**Smith River Interceptor  
Corrugated Metal Pipe Rehabilitation  
Contract III**

## ADDENDUM NO. 1

**ISSUED April 19, 2017**

### **Sheet C16**

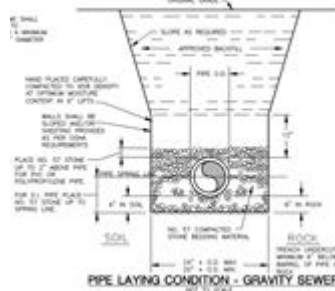
- Change note in PROFILE VIEW to state:

**“LINE OR REPLACE EXISTING 42” CMP SANITARY SEWER STA. 143+23 TO 153+03”.**
